NDS OPERATIONS PROCEDURE MANUAL
NO. P-C009

CONFIGURATION 1100/84

SUBJECT : 1100/84 Configuration Update

SUBJECT : 1100/84 Configuration

TRANSFER SWITCH ASSIGNMENTS: INTERIM CONFIGURATION

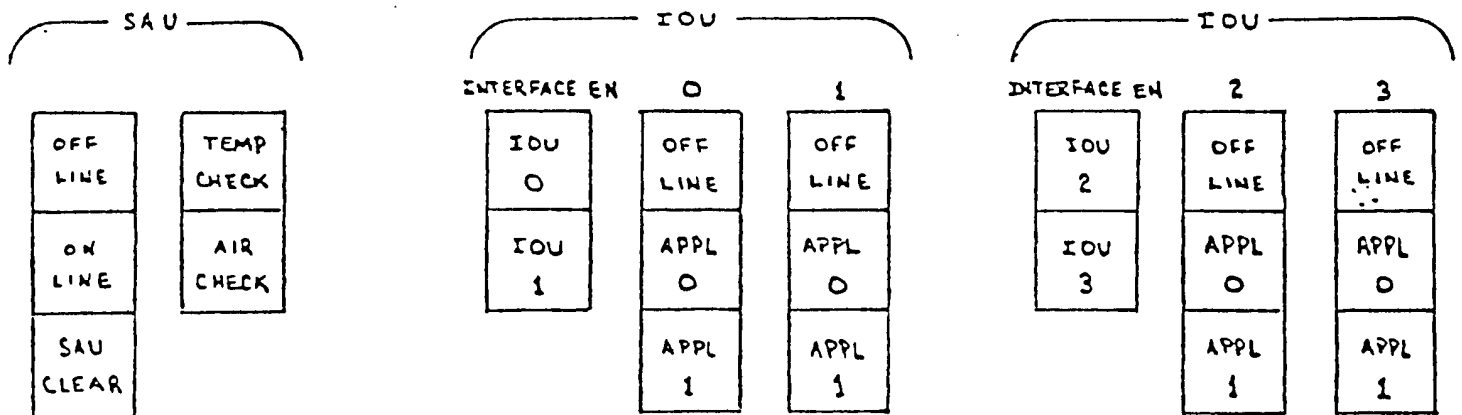
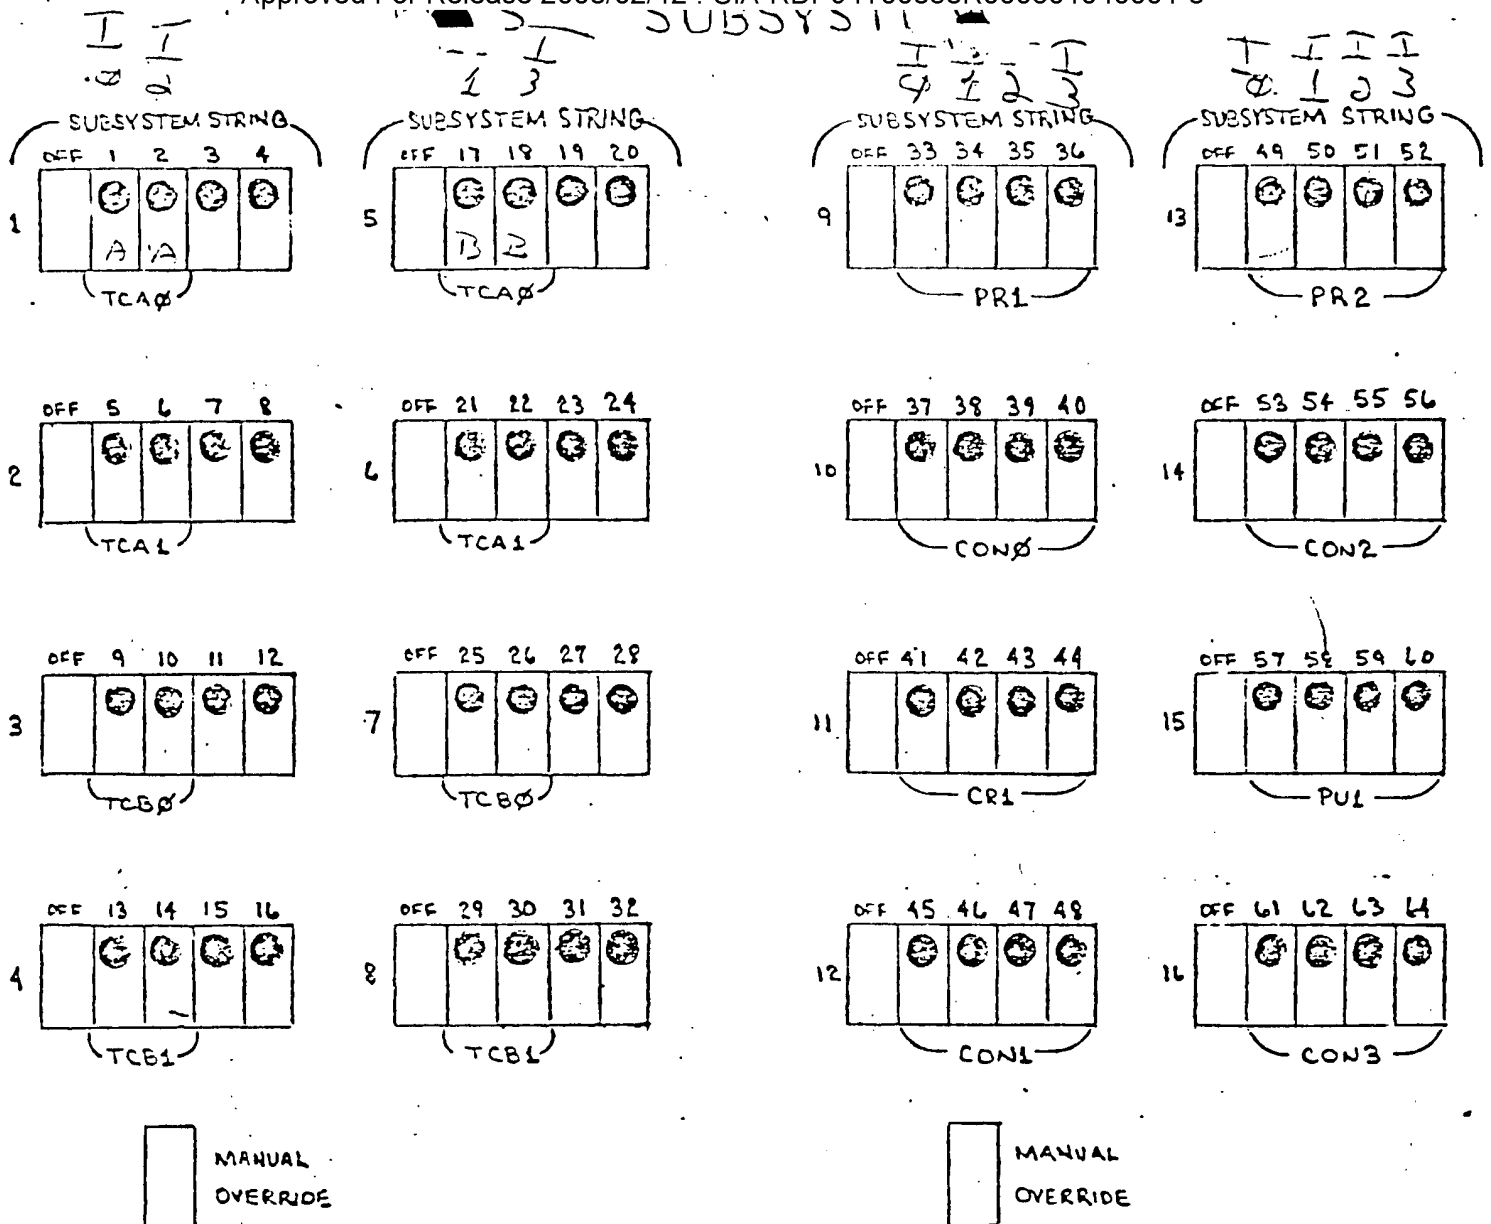
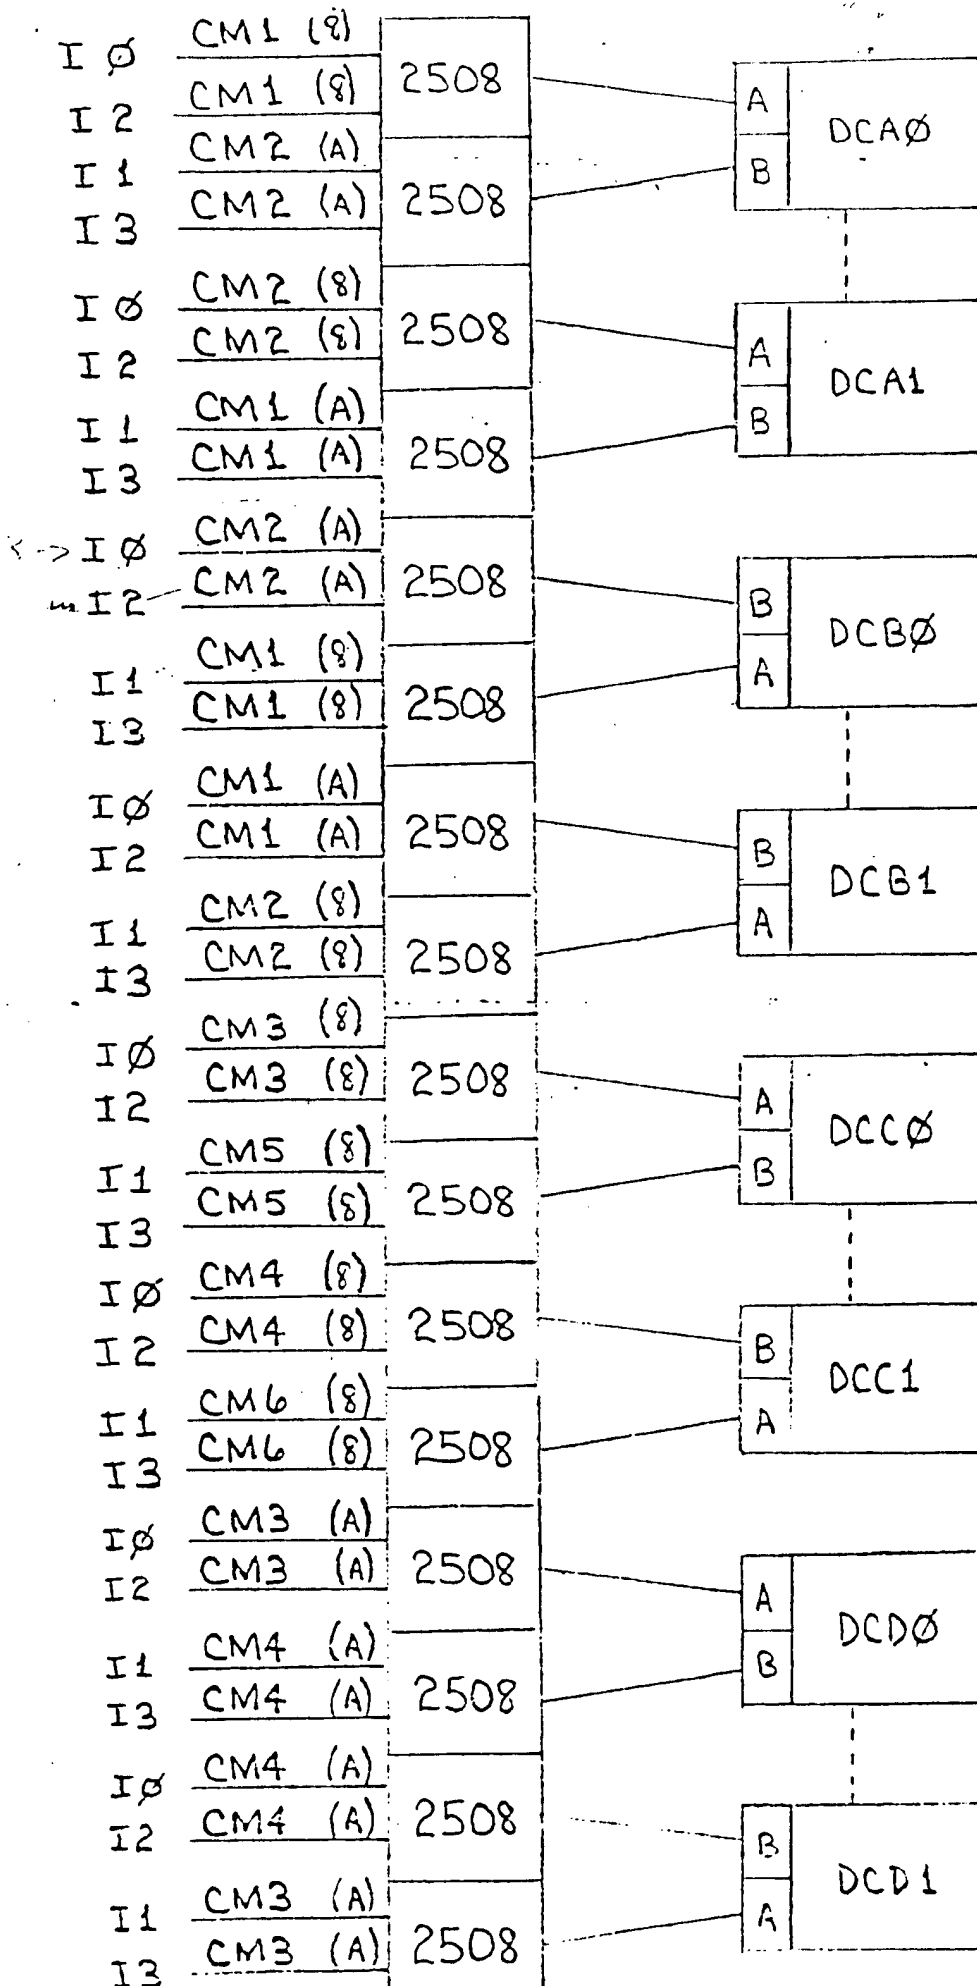
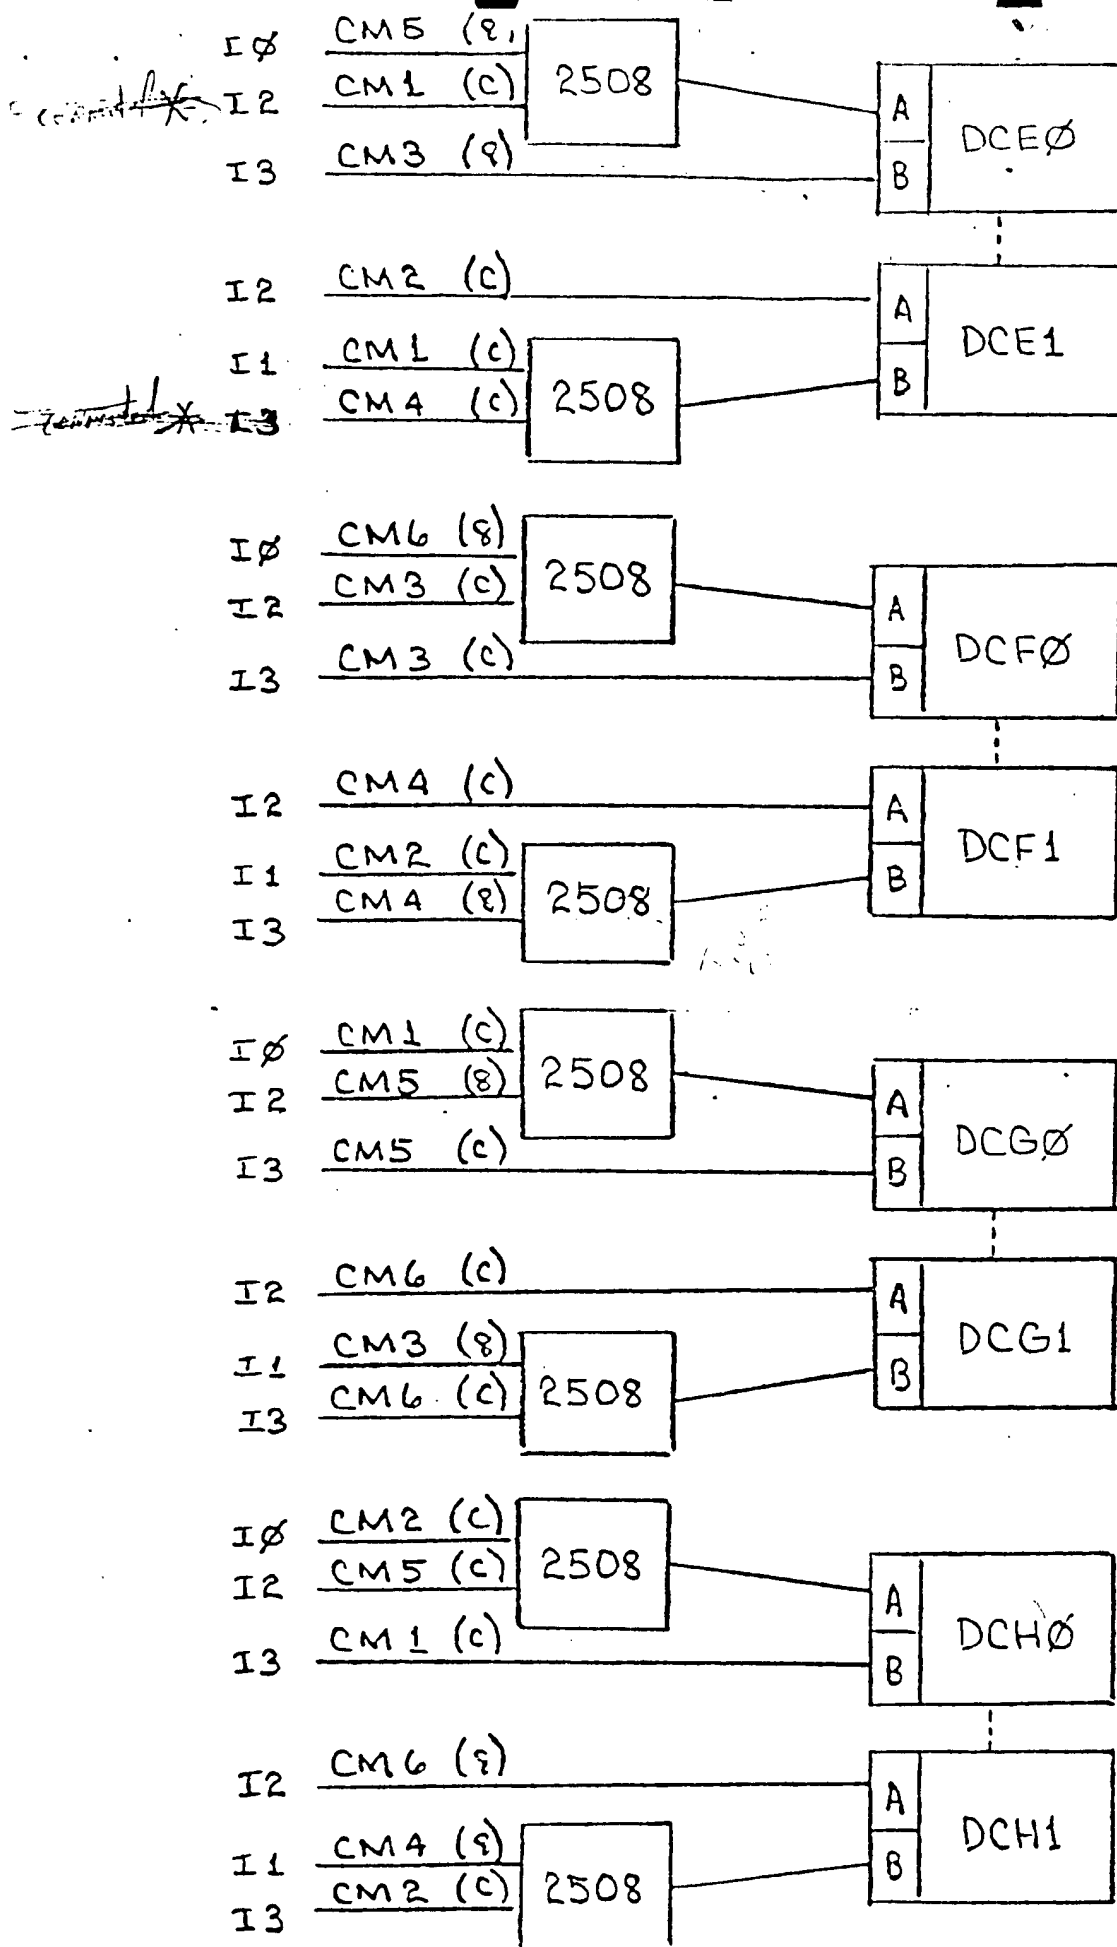
The attached 2 Diagrams are updates to the 1100/84 configuration document dated 2 September 1981. This update was necessary in order for the diagrams to correspond with the physical switch positions as connected by the UNIVAC customer engineers. In addition, the switches have been numbered on the diagrams. These numbers are being referred to in operating instructions.

C/SP CONFIGURATION

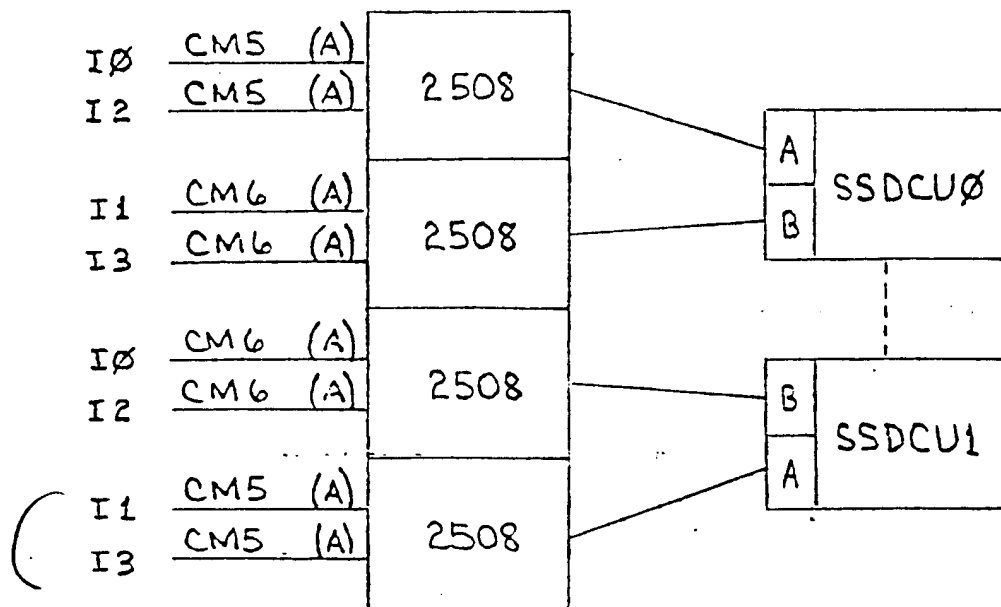
1. The control unit names are changed to match the names used in the "SYSGEN".
2. The position of the current CACHE-DISK subsystem was changed. It is now named "DCA0" and "DCA1"
3. Two new diagrams have been added:
 - a. MULTI-ACCESS SUBSYSTEMS - This indicates the positioning of "word-channel-module" devices on the SAU
 - b. BCTS SUBSYSTEMS - This diagram shows the positioning of "BYTE-MUX" and "BLOCK-MUX" devices on the SAU
